NHAI/RUPC/RudrapurBypass/2022/1916

**Subject:** Diversion of 2.183 ha Forest Land under FCA 1980 for construction / improvement of Rudrapur Bypass Road Section I (from Chainage 00+000 to 21+476) in Udham Singh Nagar District under Tarai Kendriya Van Prabhag Haldwani in Rudrapur Forest Range in the State of Uttarakhand

As per the queries raised by RO, MoEF&CC for the above mentioned project, compliance is as under:

TITLE  
PLAN & PROFILE  
SCALE:  
HORIZONTAL: 1:5000  
VERTICAL: 1:1000  
DRAWING NO. NHWA/07  
DESIGNER  
CHECKED  
APPROVED

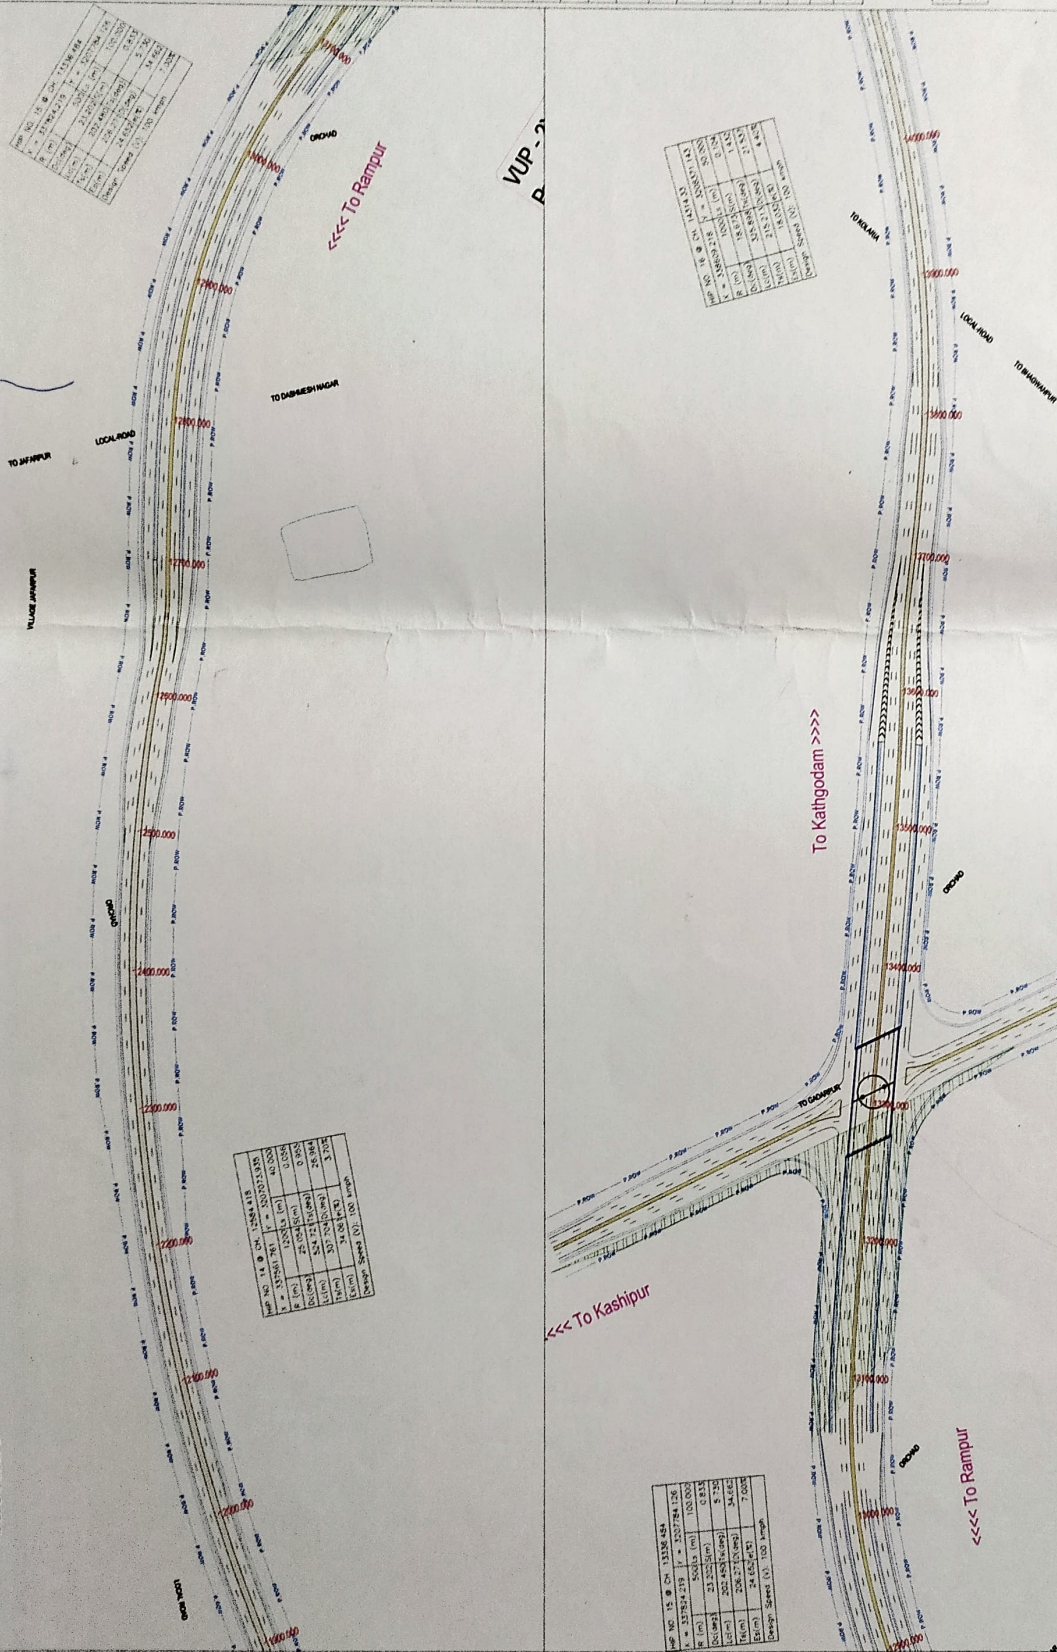
| S.No. | Query   | Compliance  |
|-------|---|---|
| 1.    | The component wise breakup of the project to be undertaken on the proposed forest land has not been provided. Accordingly, the component wise breakup along with a detailed layout plan be submitted in the online portal. The KML file shall also be corrected to reflect the component wise breakup | Compliance has been done, updated kml uploaded on portal. Layout Plan is uploaded and enclosed as <b>Annexure I</b> . KML Image is enclosed as <b>Annexure II</b>   |

# RUDRAPUR BYPASS SECTION I AFFECTED FOREST AND NON FOREST AREA

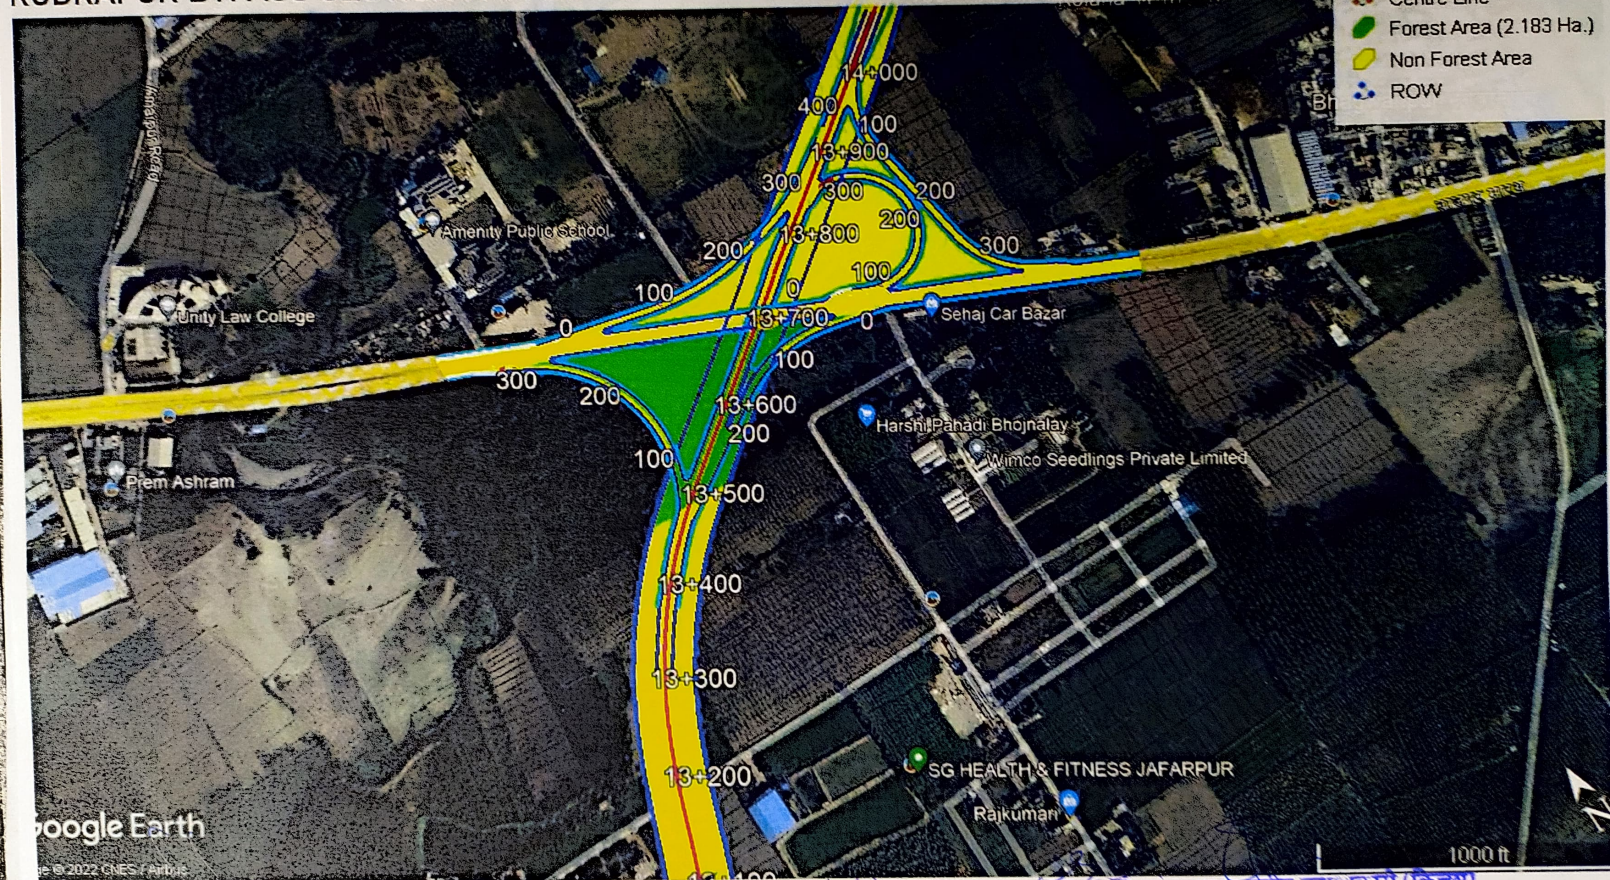
| 9 | The Length of the Road passing through the forest is mentioned as 219m in the Bar-chart and Performa 12. However in the Geologist report it is mentioned as 230m. The state Govt. is requested to do the necessary corrections in this regard.   | After preparation of Geological report there is slight modification in alignment hence there is slight change in the length of alignment affecting in forest area, although location is same and affected forest area is 2.183 ha. |
